**To:** Carolyn Ali

**Address:** Township of King

**Re:** Water and Wastewater Master Plan – Addendum Addressing Capacity Impacts Due to New Information

## MEMORANDUM

Figure 1: King City Wastewater Servicing Constraints Identified in Master Plan

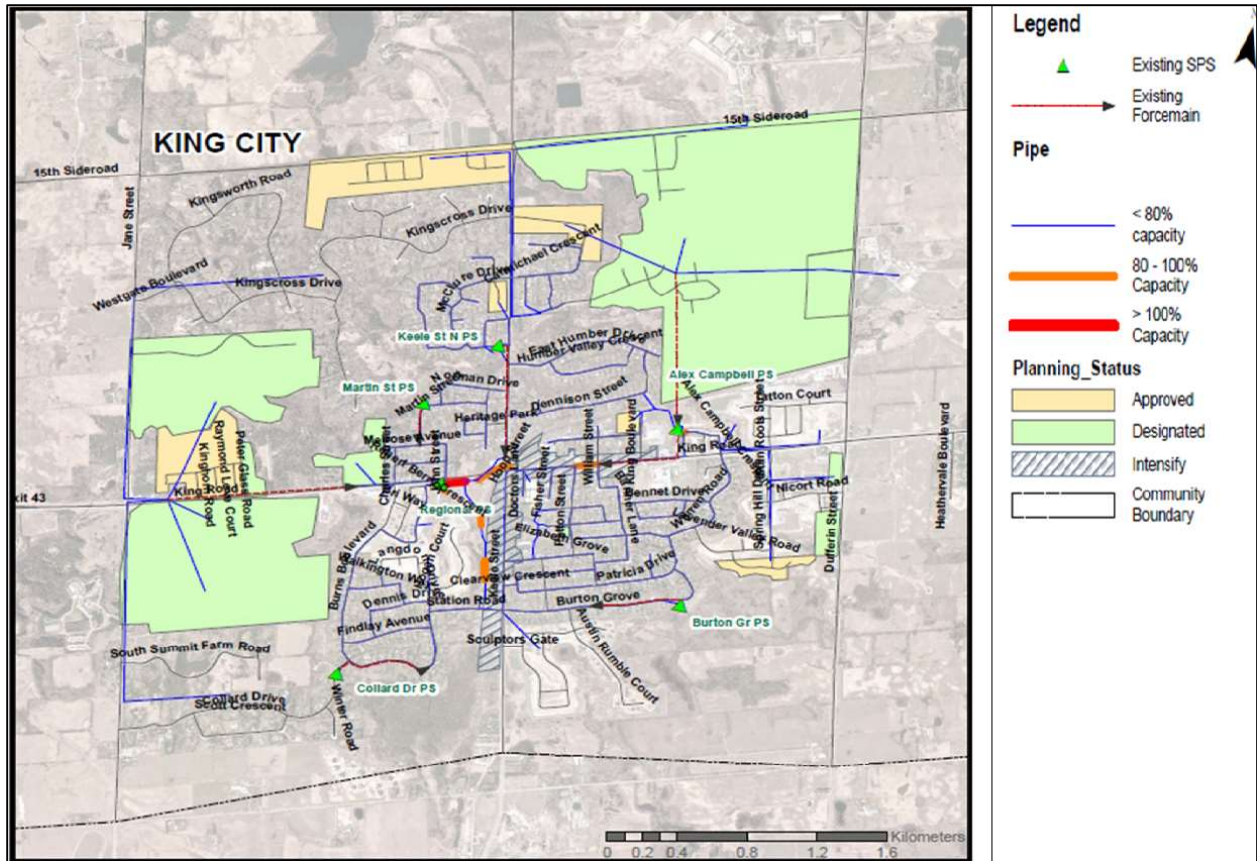
The surcharge status of the existing sewers as identified in the Master Plan is shown in **Figure 1**. The figure indicates that some stretches of sanitary sewer exceeded 80 percent of their full flow capacity, and that some of the pipes along King Road west of Keele Street were expected to surcharge under full buildout conditions (with a projected population of 15,500 residents).

Figure 2: Recommended King City Wastewater Projects

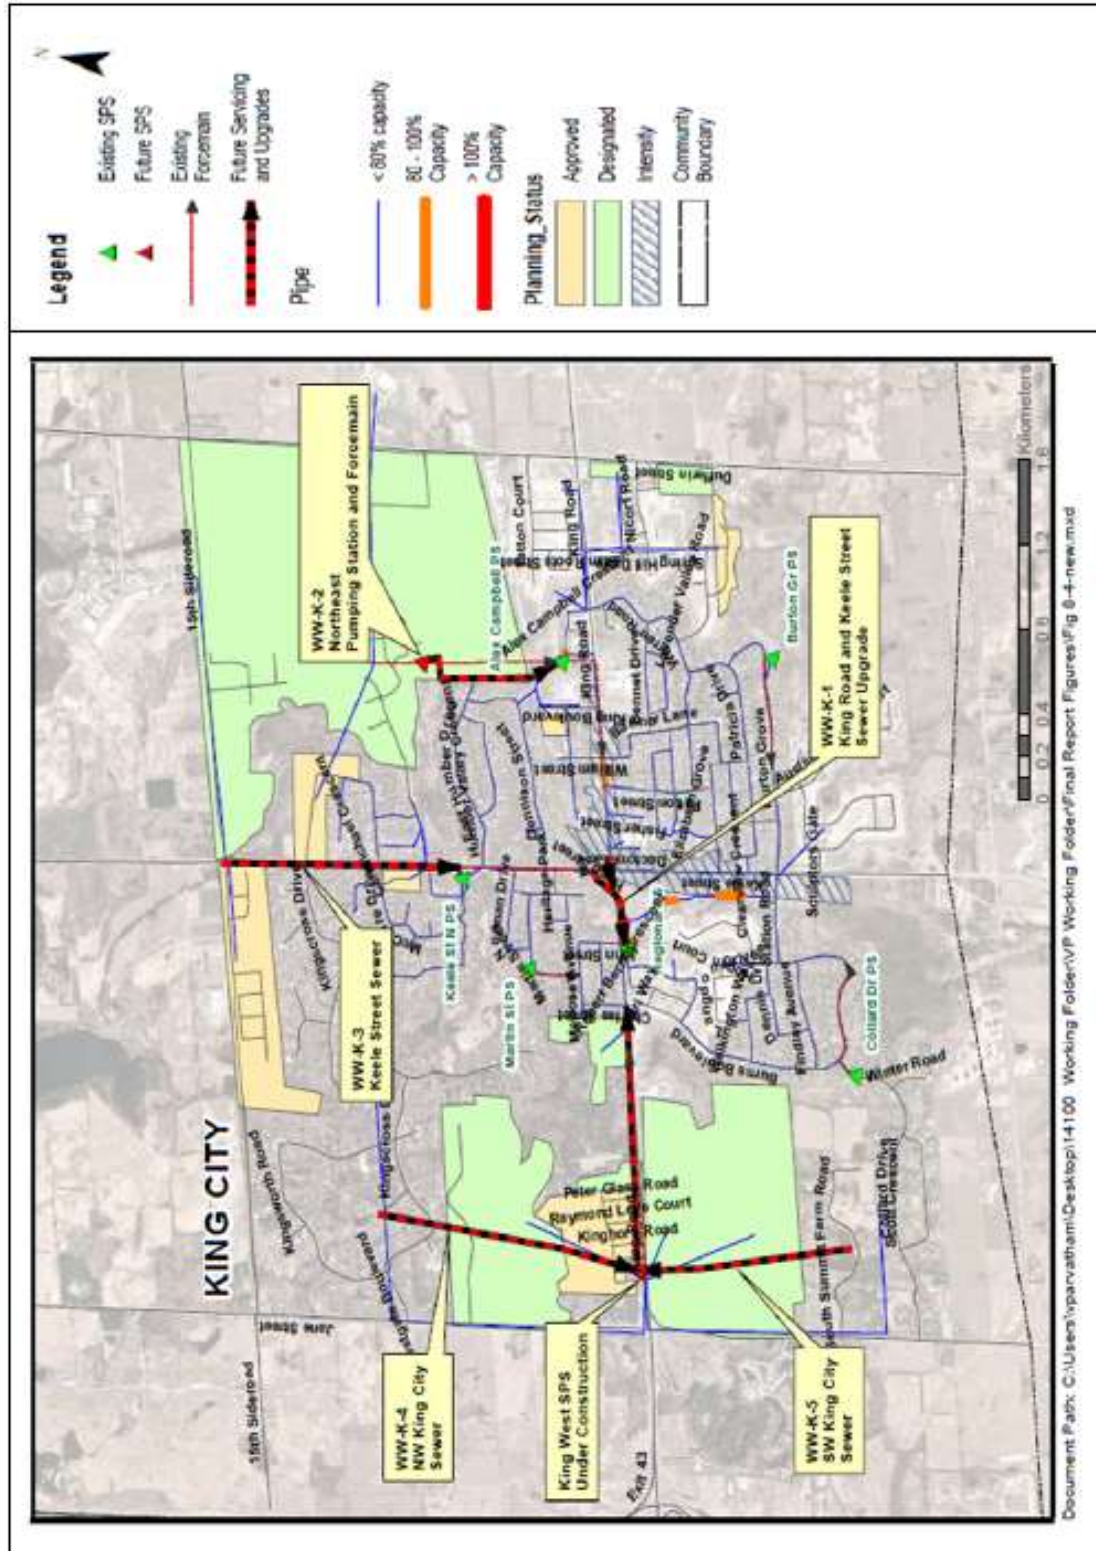
The Master Plan considered all these potential constraints and identified alternatives to be considered by the Township. The preferred alternative consisting of five projects were recommended for the King City and these are show in **Figure 2**. Out of five recommended projects, project WW-K-1 recommends upgrades at the intersection of King Road and Keele Street where the discrepancy about sewer configuration and sizes were observed.

Project WW-K-1 contemplates upsizing of the existing sewers along King Road and Keele Street upstream of the regional sewage pumping station. This infrastructure upgrade was recommended, as it to provide additional capacity required to service the existing system and planned future development in Northeast King and North along Dufferin Street.

Based on updated model results, we have determined that the original Master Plan identified project WW-K-1 which contemplates upsizing of existing sewers along King Road is not required as the existing system has sufficient capacity to service the planned growth.

**Figure 3: Wastewater Servicing Constraints at King Road and Keele Street Based on Updated Master Plan Model**

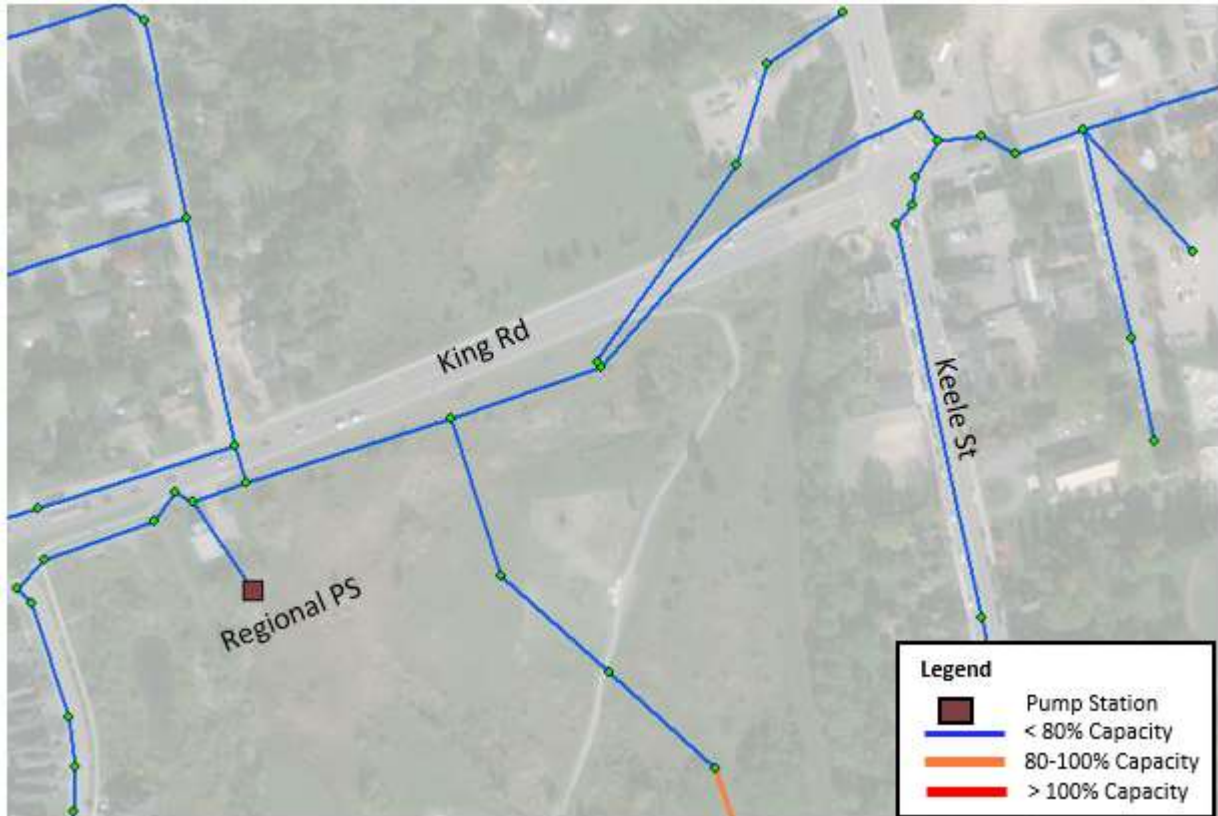
Township's Wastewater Master Plan model was updated at the intersection of King Road and Keele Street (within Project WW-K-1) with the new GIS information. The GIS information was checked against the Contract Drawing 3B received from the Township. In case of discrepancy between GIS and Drawings, information from Contract Drawings was used to update the model.

Upon review of this new information, the constraints identified in the Master Plan at the intersection of King Road and Keele Street no longer exist. The updated modelling results indicate that the existing sanitary drainage network at King Road and Keele Street has sufficient capacity to accommodate the planned future developments. The updated model results at the intersection of King Road and Keele Street are shown in **Figure 3**.
